Advisory Action Before the Filing of an Appeal Brief	Application No. 10/065,879	Applicant(s) NEWTON ET AL.	
	Examiner Jeffrie R. Lund	Art Unit 1792

THE REPLY FILED 12 November 2007 FAILS TO PLACE THIS APPLICATION IN CONDITION FOR ALLOWANCE.

Response to Arguments

Flow Pattern If The Distance Of R_n Is Different As Suggested By Examiner

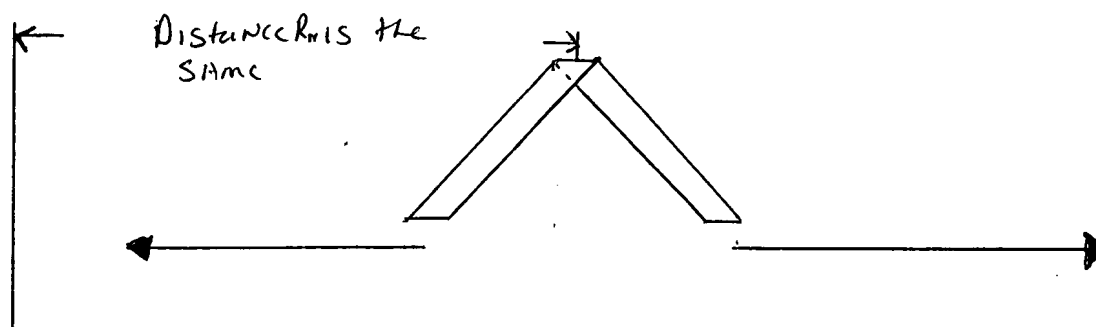
In regard to the argument that Deacon, Mitani et al, and Carpenter et al do not teach that the rings R do not increase in distance from the common point, the Examiner

disagrees. Looking at figure 19 in Deacon, it is clear that the flow arrows are aligned inwardly and outwardly and nose next to tail. As shown in figures 5 and 6 the holes that cause the flow are at an angle. Therefore, inlets to the outwardly flowing holes must be at a radius smaller than the radius of the inlets to the inwardly flowing holes. If the inlets had the same distance, the resulting gas flow would not be the same as required by Deacon in figure 19. (See figures below)

Therefore, Deacon, Mitani et al and Carpenter et al teach the claim limitation.
